MONTGOMERY COUNTY HISTORIC PRESERVATION COMMISSION
STAFF REPORT

Address:	5605 York Ln., Bethesda	Meeting Date:	9/11/2019
Resource:	Contributing Resource (Greenwich Forest Historic District)	Report Date:	9/4/2019
Applicant:	Kathryn Becker Revocable Trust (David Schindel, Architect)	Public Notice:	8/28/2019
Review:	HAWP	Tax Credit:	Partial
Case Number:	35/165-19C REVISION	Staff:	Michael Kyne
PROPOSAL:	Demolition and new construction

- **Revision** to the previously approved HAWP to alter the lite configuration of the windows in the proposed porch enclosure.

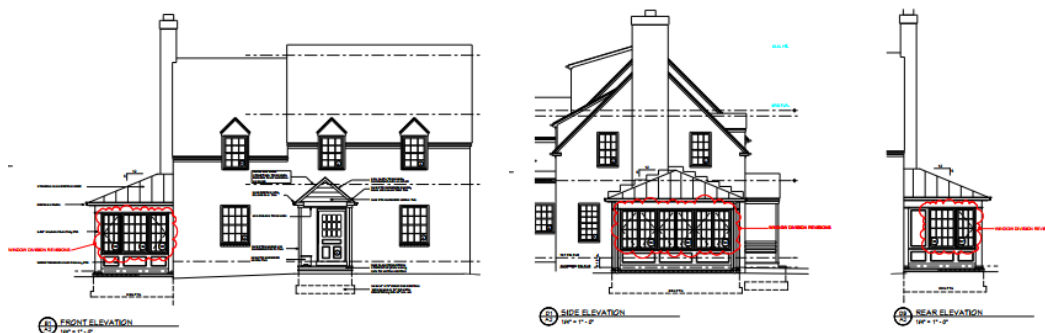
The approved construction plans specified 2X3 and 3X3 window pane divisions, shown below.

This application requests a change of window pane divisions to 3X4 and 4X4, shown below.

The original selection of fewer and larger window panes was based on the desire to maximize interior light and landscape views by reducing the number of muntins and mullions. The 2X3 and 3X3 window pane configuration was also consistent with the existing sash windows in the house which are 3X3 and 4X4.

After the HAWP application was approved, we realized that the individual panes in the approved plans would be 11" X 17". This is much larger than any panes anywhere in the house. To match the scale of windows elsewhere in the house, we are proposing windows with 3X4 and 4X4 panes. This formula and the size of individual panes (6.75" X 13") are consistent with other windows in the house.

Per the June 12, 2019 approval, the windows of the proposed study/screened porch enclosure would have 2x3 and/or 3x3 lite configurations; however, the applicant found that the individual window lites, measuring 11” x 17”, were too large and inconsistent with the existing windows of the historic house. The applicant proposes to revise their proposal, resulting in windows with 3x4 and/or 4x4 lite configurations and individual lites measuring 6.75” x 13”. According to the revised application, the size of the individual lites will be consistent with the existing windows of the historic house.
